Major System: REAR AXLE

SB-10056352-3070

Title: Torque change for 5/8 inch rear axle shaft flange mounting stud with cone locks and flat washer type hardware.

Figure 1 (Inspection)

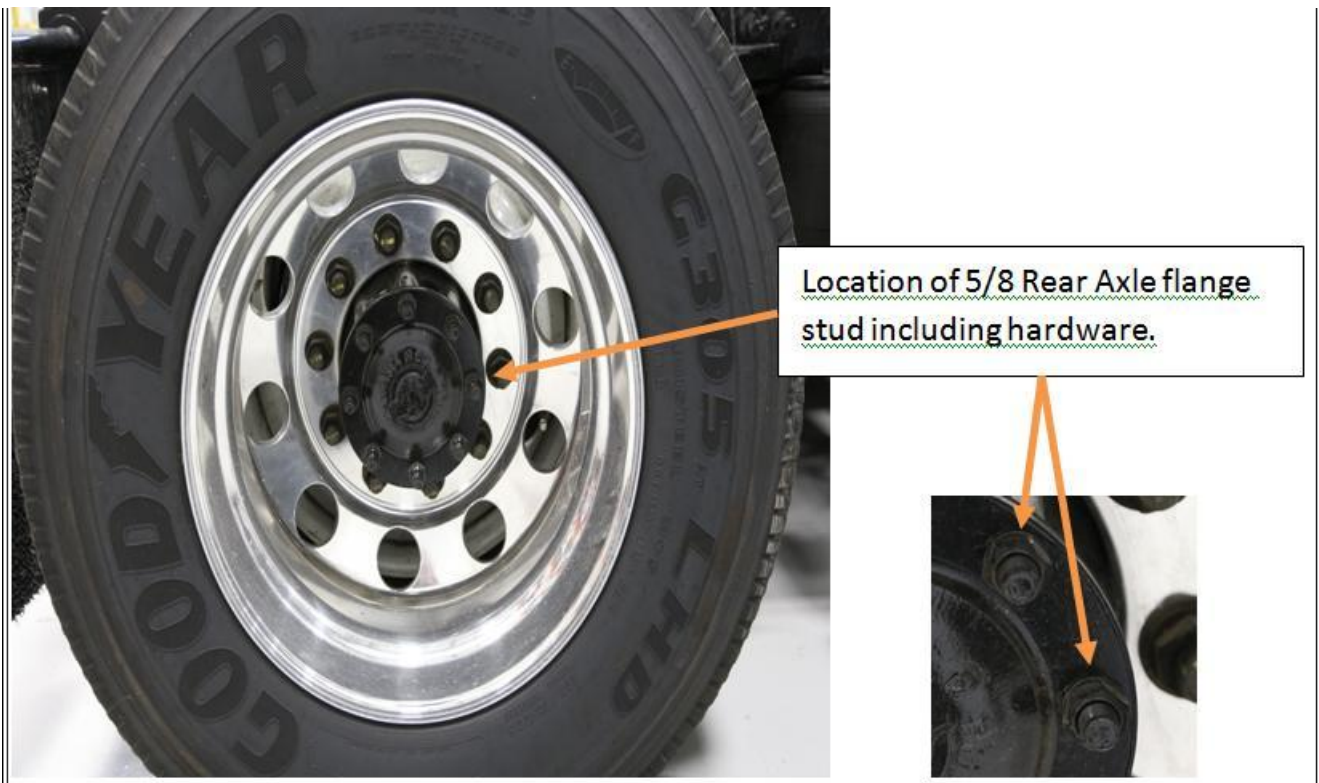
- 1) Inspect for missing or loose 5/8 axles shaft hardware (Figure 1).
- 2) If any loose or missing hardware is found, replace missing 5/8 rear axle flange hardware
- 3) Re-torque all 5/8 rear axle flange hardware to 145 - 175 ft*lbs using correct torque sequence (Figure 2)

The required torque for 5/8 inch rear axle shaft flange mounting stud hardware has been increased. Torque has been increased to 145 - 175 ft*lbs with both cone lock and flat washer type hardware . This will address the issue of missing or loose 5/8 studs, and leaking gaskets.
